St. Joseph Wind Farm Inc.

St. Joseph Wind Energy Project Environmental Impact Study Report Volume 3 - Revised Project Description and Response to Agency Comments

Submitted to :
Manitoba Conservation
Canadian Environmental Assessment Agency

June 2009

VISUAL SIMULATION 4
View from Letellier, Looking West

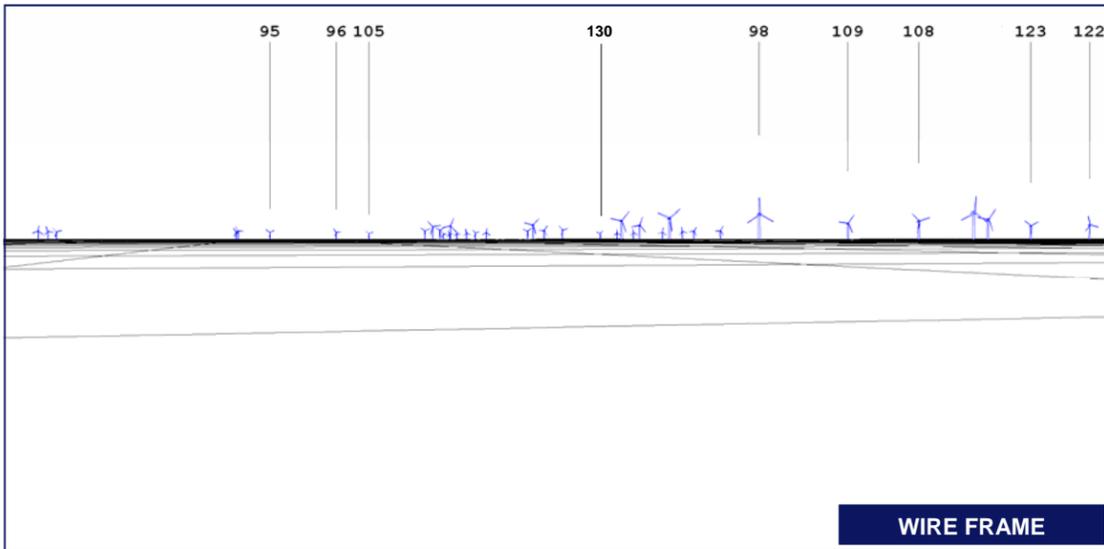
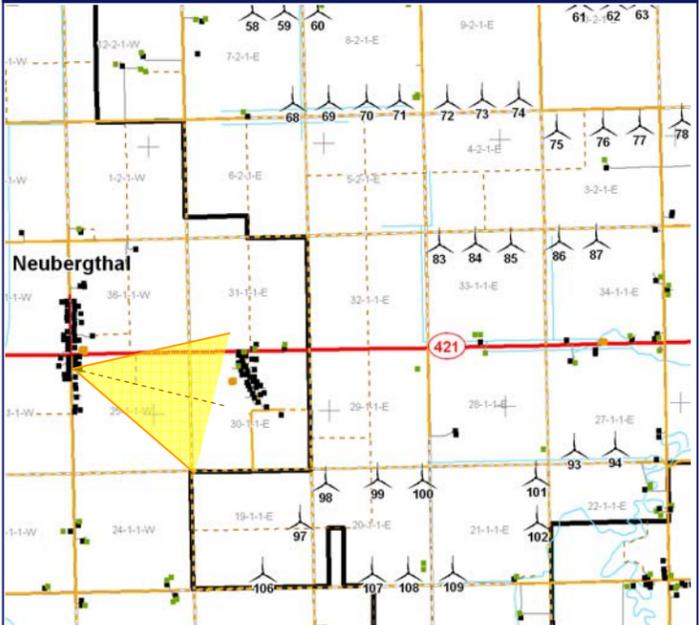
Notwithstanding previous efforts on the part of the proponent in relocating turbines to minimize visual impact, Parks Canada recommends relocation of turbines 139-142; 123-128; and 154 to 158 due to potential effect on the heritage value associated with the Neuberghal Street Village National Historic Site.

2. Parks Canada recommends turbines 123 –128 and turbines 154 –158 are removed from their proposed location on map 5.2, dated July 16, 2008. Both lines are very visible along northeast and southeast planes respectively. Therefore Parks Canada recommends that there should be no turbines:
 - within 3.2 kilometres of the village, nor
 - on the 9 sections to the east of Neubergthal (1-2-1-W, 36-1-1-W, 25-1-1-W, 6-2-1-E, 5-2-1-E, 31-1-1-E, 32-1-1-E, 30-1-1-E, 29-1-1-E), nor
 - within 5 miles of the village along Highway 421 to protect that line of sight.

As indicated previously, all recommendations were considered in the revised turbine layout. The constraints map (Map 2) indicates the setback area recommended as a “National Historical Site” area to be avoided.
